MILITARY SPECIFICATION

DETECTOR, WIND DIRECTION, SPEED, AND TEMPERATURE, FIRE AND FLIGHT AIR DATA SUBSYSTEM, HELICOPTER ARMAMENT: M143

This amendment forms a part of Military Specification MIL-D-70487 (AR), dated 30 June 1983, and is approved for use within the U.S. Army Armament, Munitions and Chemical Command, and is available for use by all Departments and Agencies of the Department of Defense.

FIGURE 7 VIBRATION TEST CURVE FOR EQUIPMENT TRANSPORTED AS SECURED CARGO

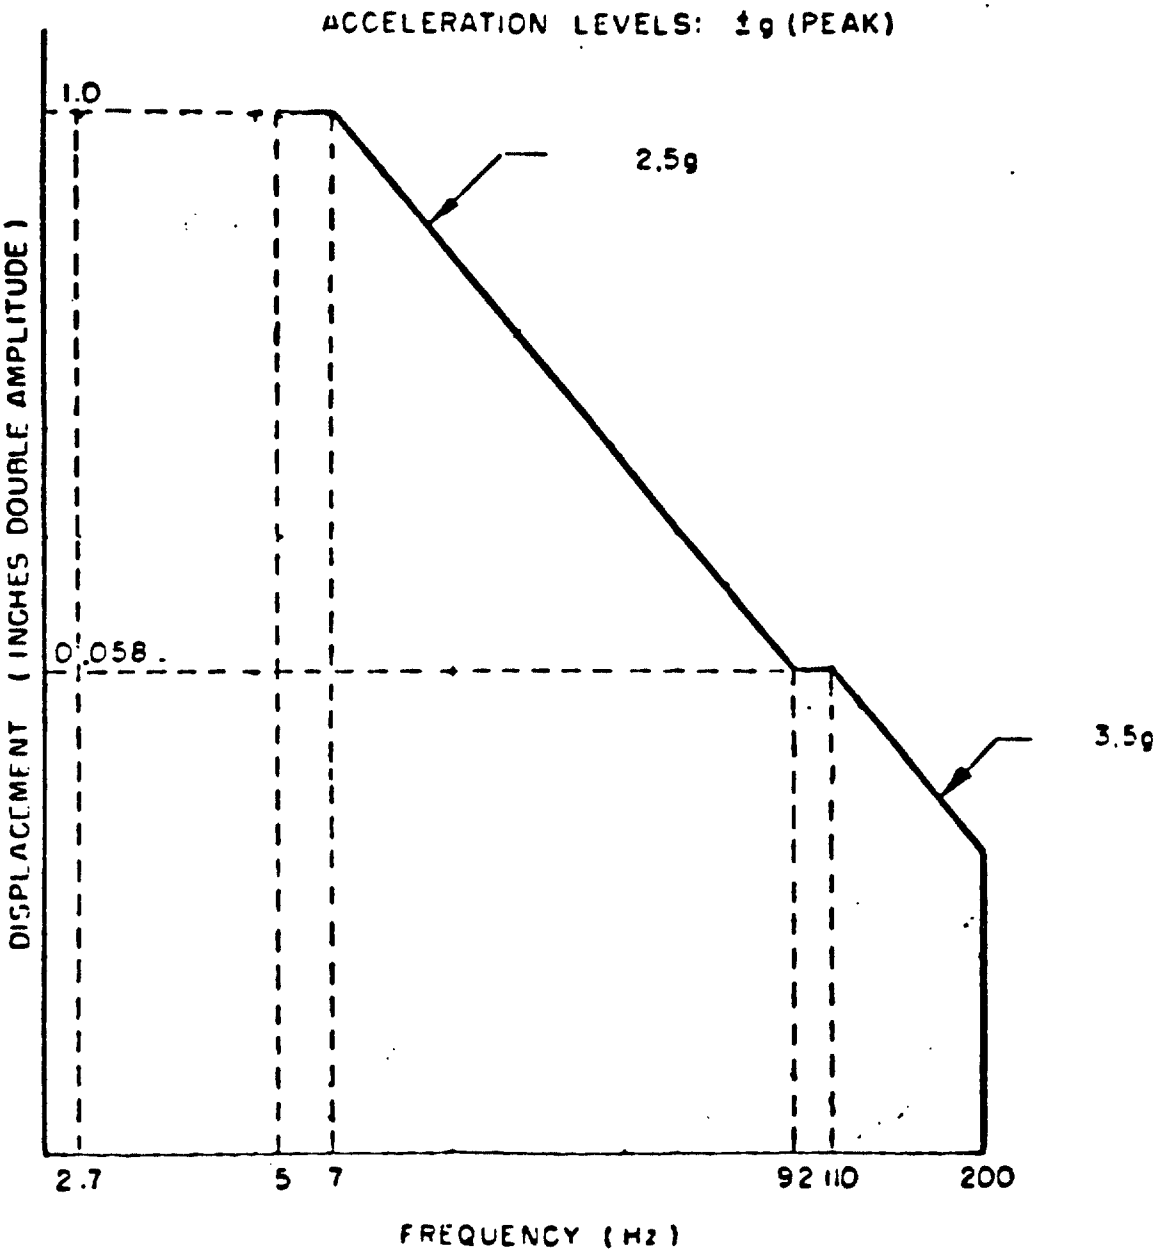
4.6.4.11.3: Delete in its entirety and substitute:

Add enclosed figure 7 (28A).

"4.6.4.4 Transportability. The AADS shall be unpacked and secured to the vibration table and shall be vibrated along each axis at the sinusoidal frequencies and amplitudes depicted in Fig. 7. The frequency of applied vibration shall be cycled logarithmically from 5 to 200 to 5 Hz, each cycle having a sweep time of 12 minutes. The system shall be exposed to the cycling for 84 minutes per axis. The AADS will not be operated during vibration. At the conclusion of this test, subject the AADS to the performance tests of Table III.".
